Visio/phone meeting 2009
24th Mar 2009, 14:00-16:00 (French-time)

Minutes

5) Reviewers opinions (P. Coleman-Smith)

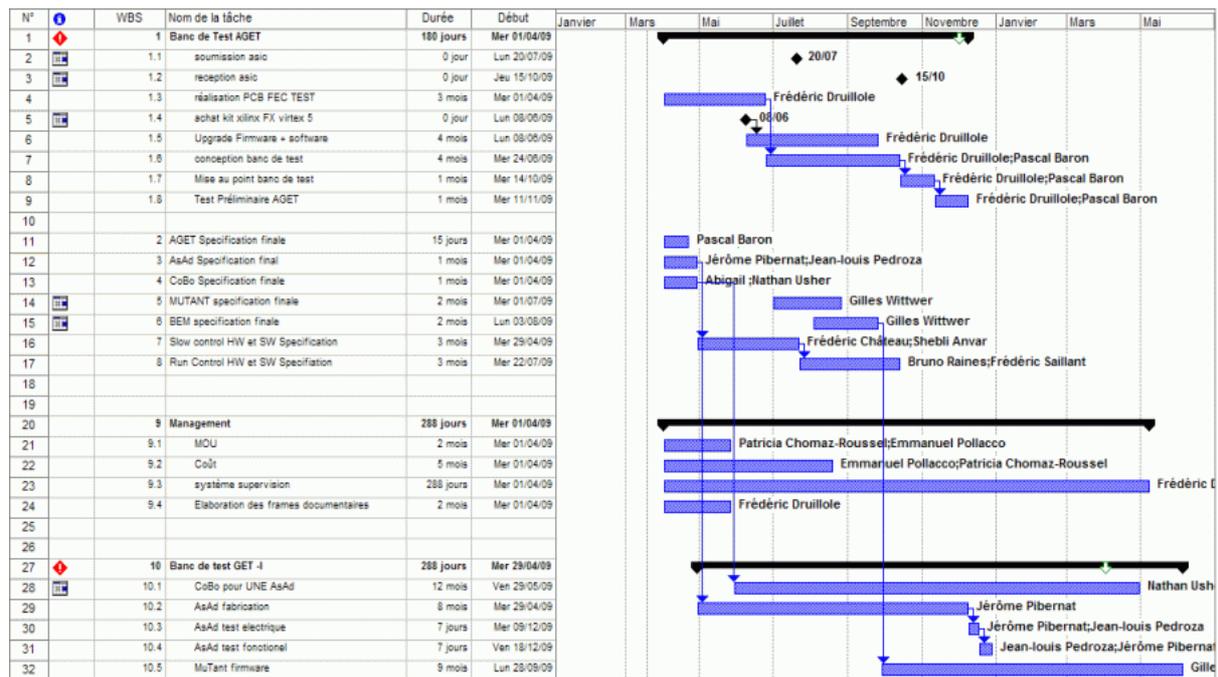
The system as presented is very complex and a lot of thought has gone into the generation of the drafts. Some thought concerning the system test and calibration including the trigger setup would be useful.

The System document from Saclay doesn't match up with the CoBo and MuTanT when discussing the trigger mechanism, communications and the system calibration. I expect this will be addressed in the full versions of the documents. There is a lack of clarity about the event rates needed in the different experiments and the effect these have on the rate the equipment operates. The system document discusses the trigger methods and needs some clarification. A graphical representation of the interplay

between the % of active ASIC channels, the clustering of channels within an ASIC, the readout of specific channels and the compression needed to move the data off the CoBo would be a help. Regarding the CoBo requiring two Ethernet ports and hence two processors. If the use of these two communications routes is considered isn't it the case that slow control to alter the setup generally means that data from the experiment is not really important. So this would usefully be shared Transfer of data between two FPGAs within the board increases the complexity. Two Ethernet ports also doubles the number of network switches required.
